Product Change Notice (PCN)

Subject: Change Lid Supplier on Select Packages

Publication Date: 2/7/2022

Appearance Comparizon

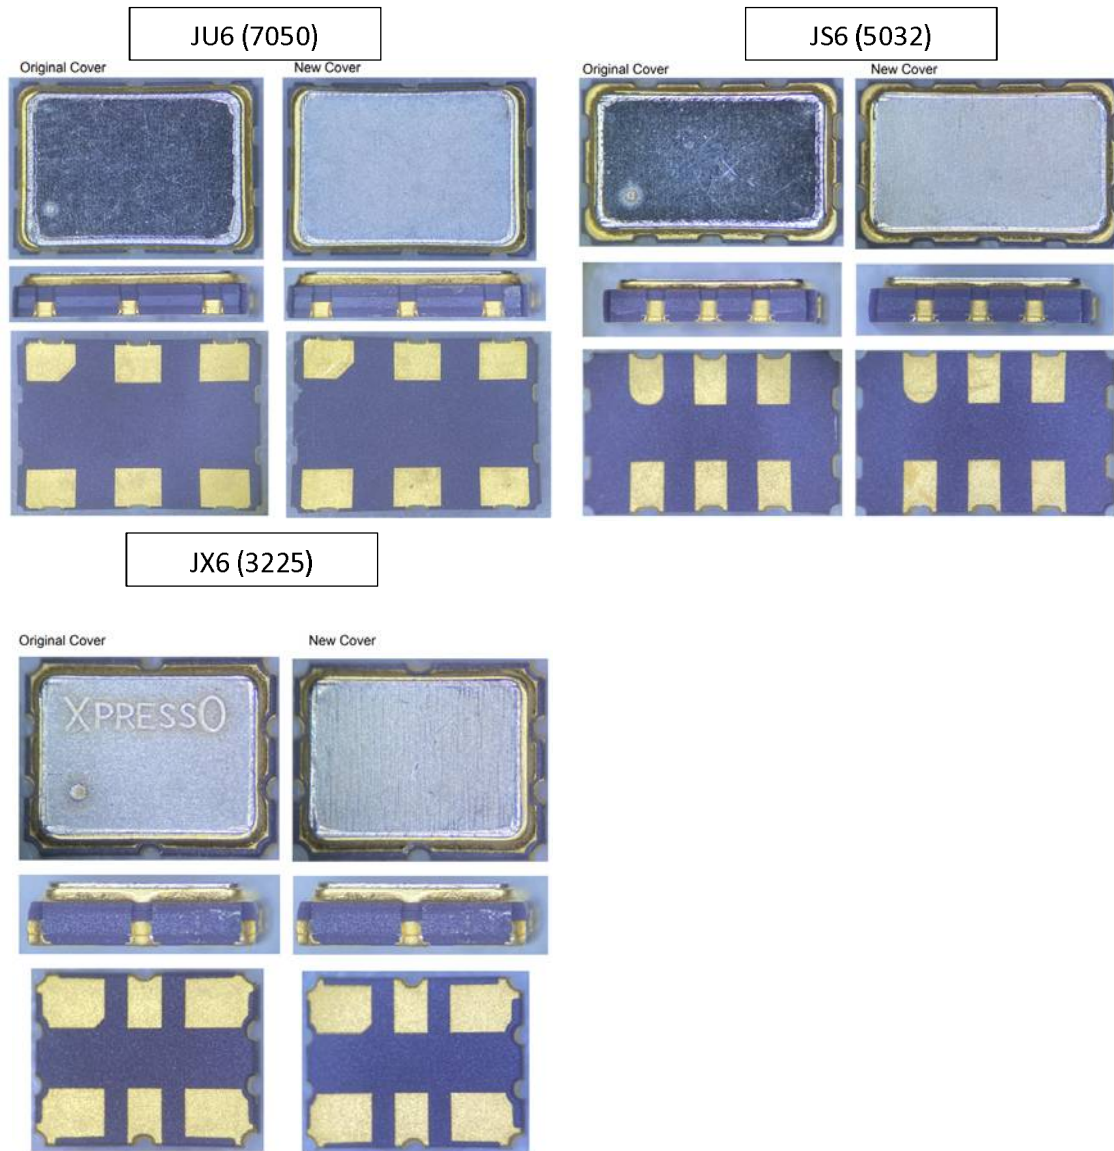
The change will have no impact on the fit, function, quality, reliability and environmental compliance of the products. However, the form in specific the lid appearance is changed due to the absence of Phosphorus element in the new lid material. Refer to photos shown in page 2.
